**From:** [REDACTED]  
**To:** [Southampton to London Pipeline Project](#)  
**Cc:** [REDACTED]  
**Subject:** SLP: Turfhill Park - Deadline 6 Submission  
**Date:** 04 March 2020 10:29:06  
**Attachments:** [SLP - Responses Deadline 6 Final3 2 20.docx](#)  
**Importance:** High

**SLP PIPELINE  
TURFHILL PARK, LIGHTWATER, SURREY**

**Opposition of Heronscourt and Colville Gardens  
Residents' Associations to the route of the  
Southampton to Heathrow Pipeline across  
Turfhill Park**

**Presentation to the Examining Authority  
Ahead of Deadline 6: 05/03/2020**

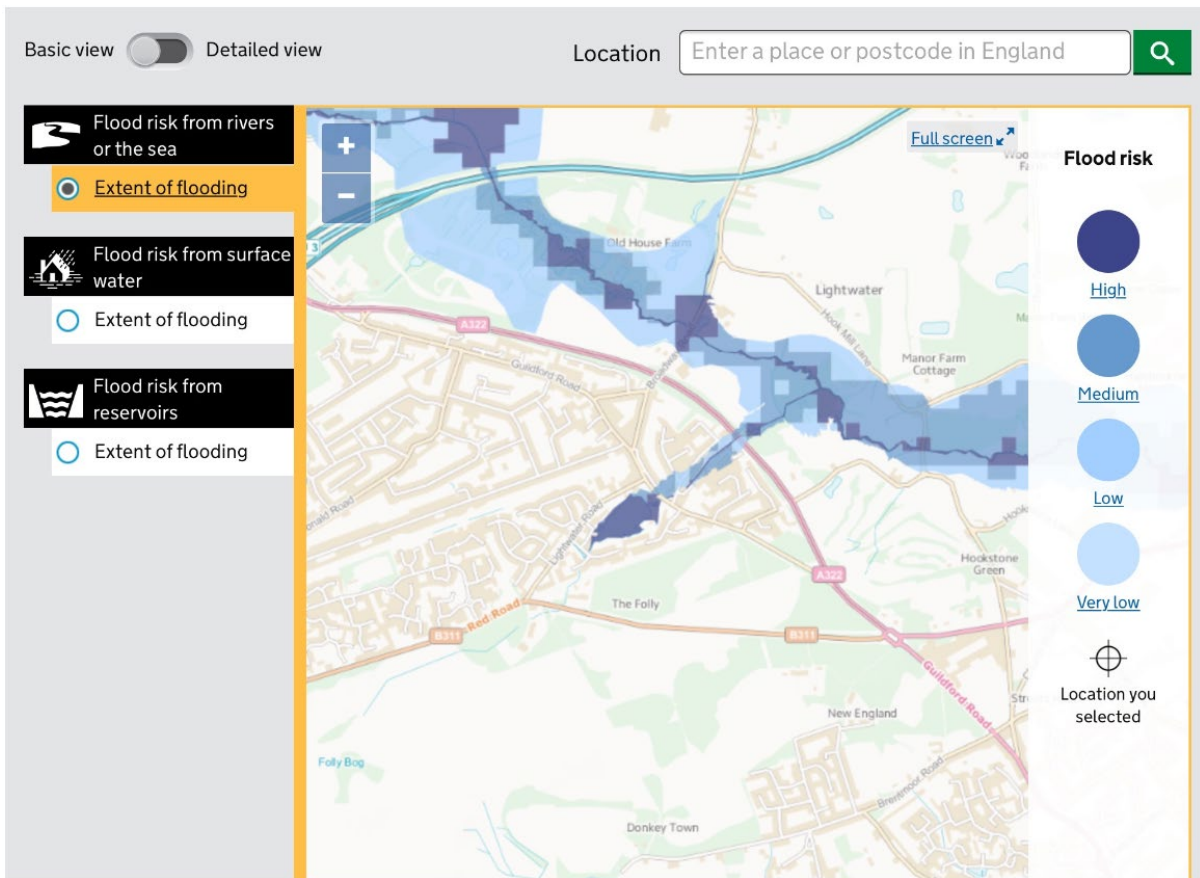
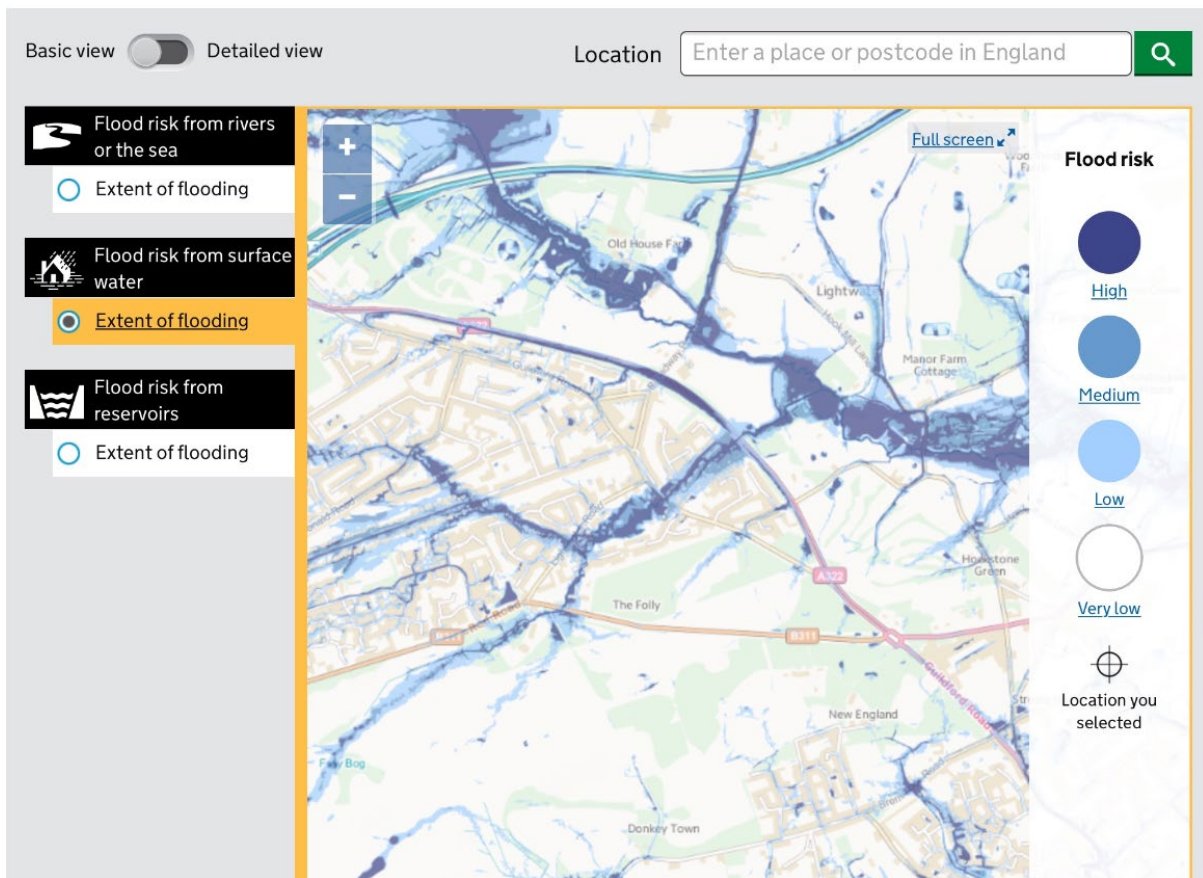
Attached at Appendix 1 and 2 are maps which reaffirm that F1a, particularly adjacent to Colville Gardens which sits immediately below the highest point of Turfhill, is a high risk area for groundwater flooding. Its associated lake on the second map shows that it has a high risk of flooding and did so in 2007/8 when the Riverside Avenue Estate across the Guildford Road suffered substantial flooding.
